# ADDENDUM No. 1

## RFP No. 24-10

### 2024 Miscellaneous Utilities Project

**CITY OF ANN ARBOR - PUBLIC SERVICES - ENGINEERING**  
**ANN ARBOR RAILROAD / BOARDWALK CULVERT IMPROVEMENTS PROJECT**

**Measurement and Payment**

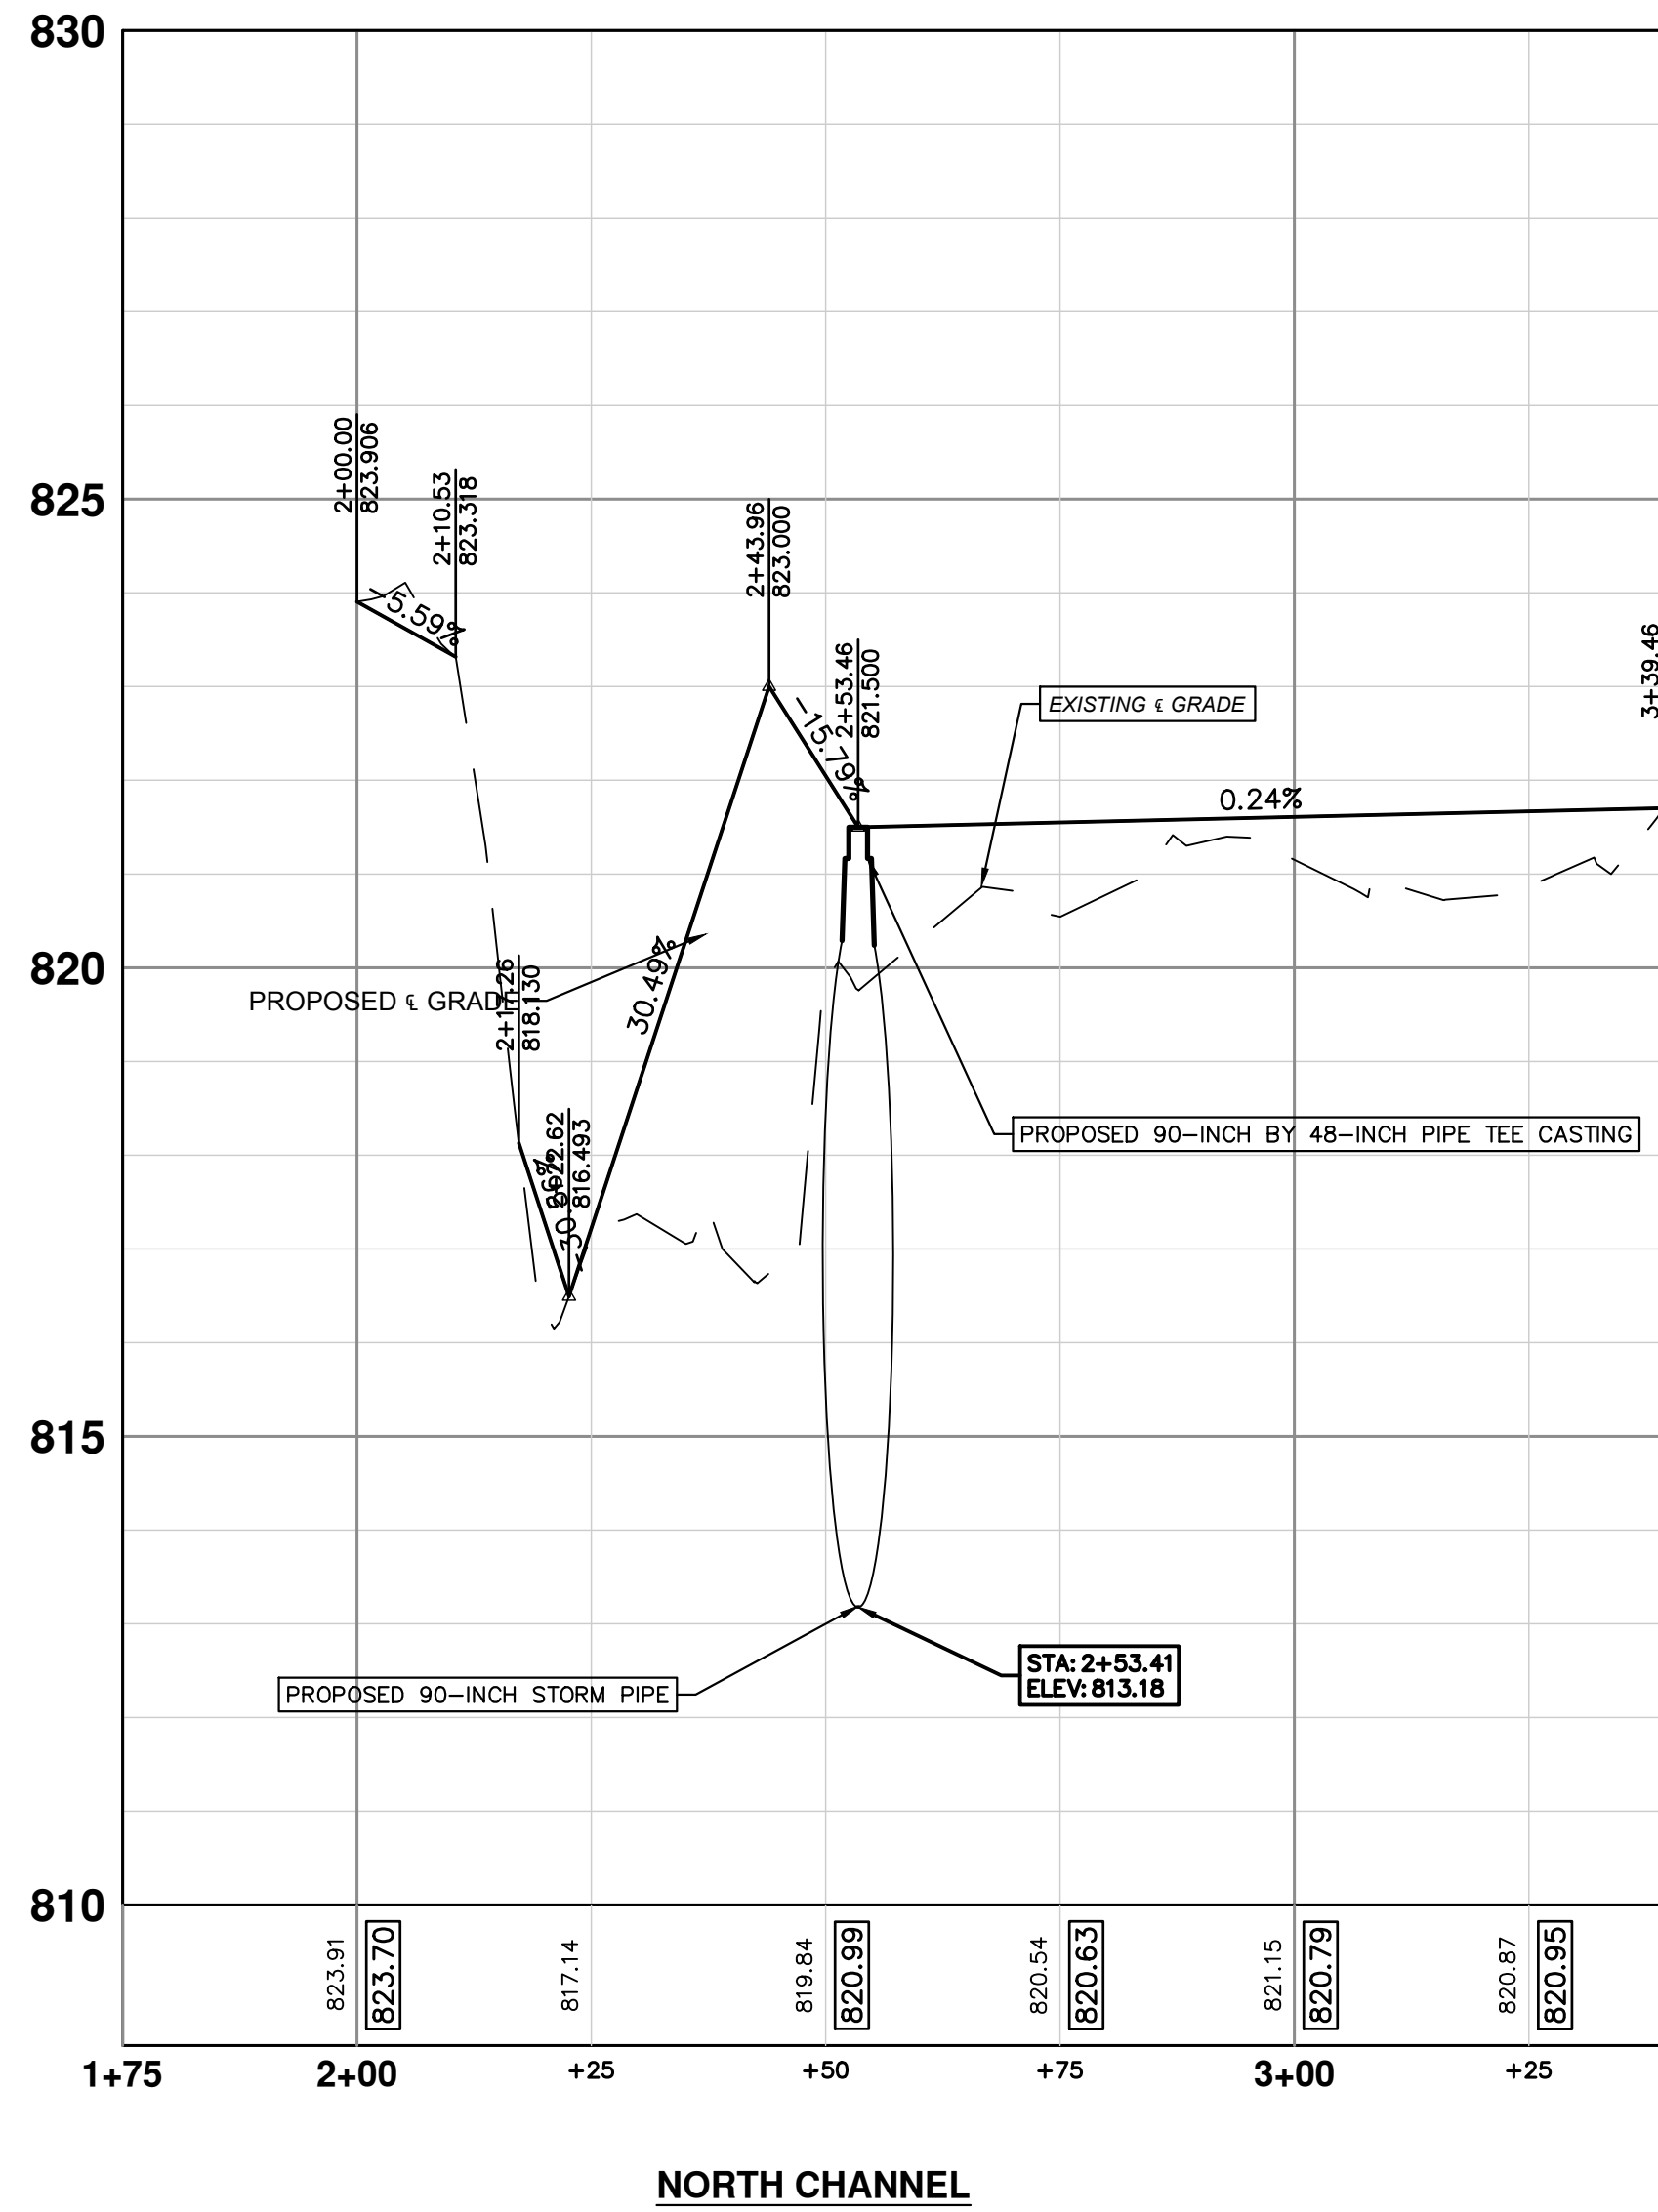
Sheet 8 of 9  
Channel Profiles

Profiles updated

NOTE: MUD MAT IS A PROPOSED ACCESS PATHWAY TO THE 90-INCH STORM SEWER REMOVAL AND REPLACEMENT. REMOVAL OF THE EARTH ASSOCIATED WITH THE PIPE REMOVAL WILL BE INCLUDED IN THAT REMOVAL PAY ITEM WHILE REMOVAL OF EARTH FOR THE MUD MAT INSTALLATION WILL UTILIZE MACHINE GRADING, MODIFIED
